## Design Review Subcommittee (DRSC)

Meeting Date: April 24, 2019

**SUBJECT:** **Cultural Heritage Permit 19-052 / Conditional Use Permit 19-053, Del Mar Restaurant**, a request to demolish a one-story office building and construct a two-story restaurant with indoor live entertainment, amplified sound, and full alcohol service at 226 Avenida Del Mar. The project also includes a proposed lot merger with an adjacent three-lot parking lot (058-111-14, 058-111-15, and 058-111-16).

**North Elevation**

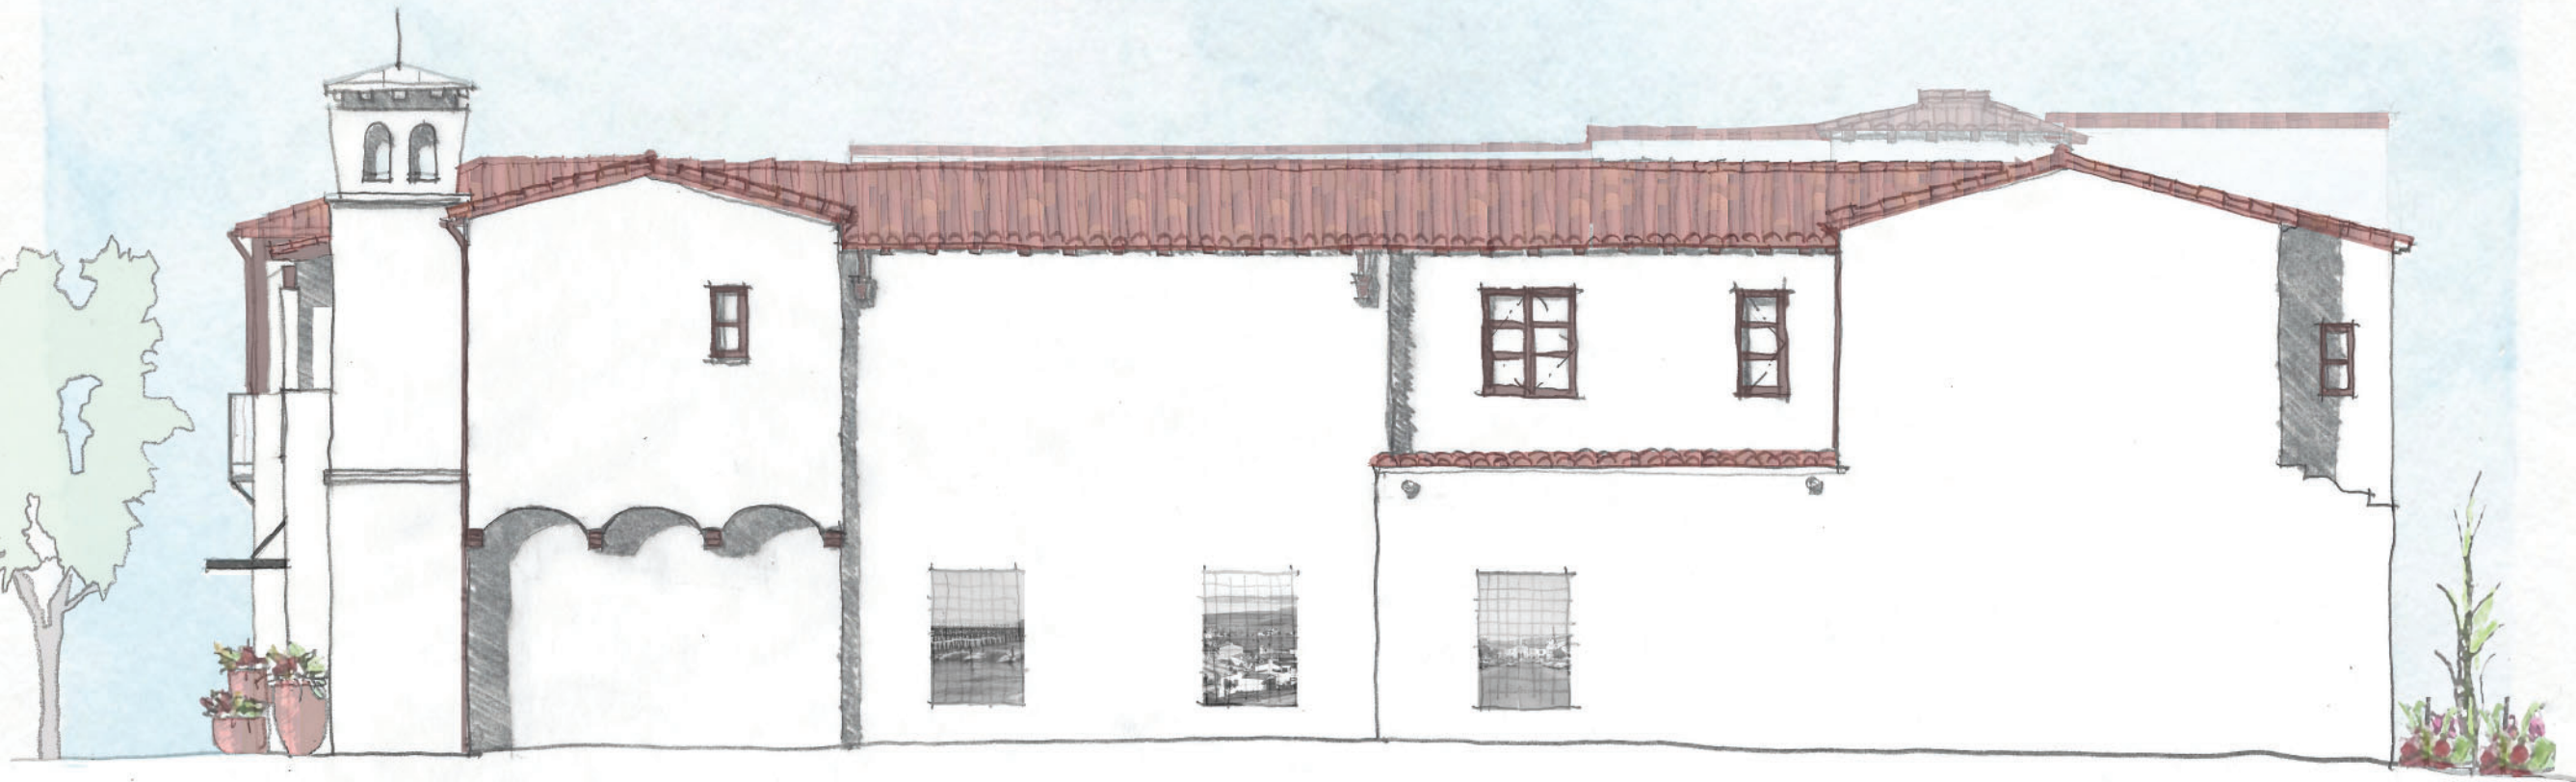
1. Add divided lites on Del Mar-facing windows and doors to improve visual interest.
2. Incorporate additional ornamental elements to the rear entry for improved visual interest from the parking lot, such as an awning or exterior light fixture.
3. Provide recessed doors and windows on the rear elevation to strengthen the project’s four-sided architecture.

7. Remove the ridge from the elevator tower to reduce clay tile mass and for a more defined tower feature.
8. Add window planter boxes or vertical landscaping on the west elevation to further mitigate impacts on the historic resource.

9. The far right wall plane on east elevation consists of a large blank wall that does not promote a human-scaled design. Add more detail on the subject wall plane such as windows, a shed roof, or ornamental elements scaled to human size to improve the pedestrian experience along the paseo.
